BCA & ACCESS ASSESSMENT REPORT

PROJECT: New High School in Bungendore PREPARED FOR: Hindmarsh

Revision 3 Date: 7 September 2021 Reference: 210035

Figure 8: Building C Ground Floor Wood & Metal Works Doorway Circulation

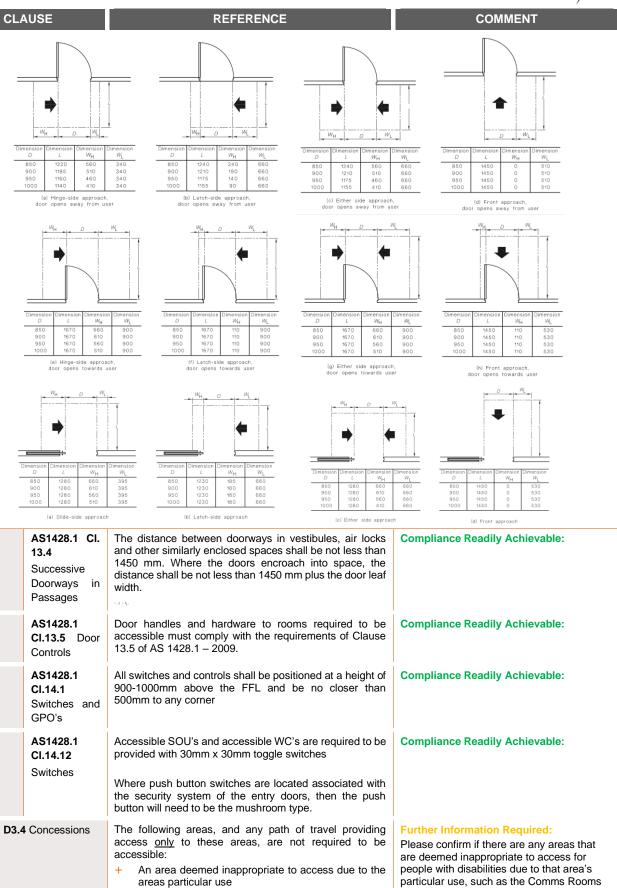
| BCA (DTS) CLAUSE | | | DESCRIPTION |
|----------------------------|-------------------------|-----|--|
| 2. | AS1428.1 13.2 / 13.3 | CI. | To allow the existing walls on the Ground Floor of Building C, Wood and Metal Tech. Rooms Type 5 to not achieve the required 510mm latch-side door clearance with the door opening away from the user as shown in Figure 8: Building C Ground Floor Wood & Metal Works Doorway Circulation |

| BCA (DTS) CLAUSE | | | DESCRIPTION |
|------------------|------------------|-----|---|
| 3. | AS1428.1 13.3 | CI. | As per Figure 5 to Figure 8, there is a lack of doorway circulation space at doorways. As these spaces are believed to be accessible, re-design is required to ensure that the minimum required doorway circulation spaces are achieved. |

Figure 13: Building AB Accessible Changeroom

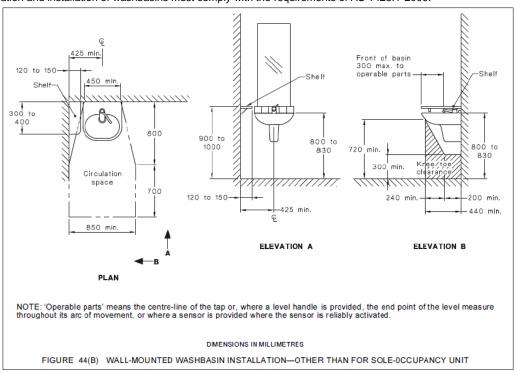
| BCA (DTS) CLAUSE | | | DESCRIPTION |
|------------------|------------------|-----|---|
| 8. | F2.4 | | Confirmation is required as to who will use the Accessible Changeroom in Building AB noting that males and females must generally not share sanitary facilities. |

Confirmation is required as to who will use the Accessible Changeroom in Building AB noting that males and females must generally not share sanitary facilities.
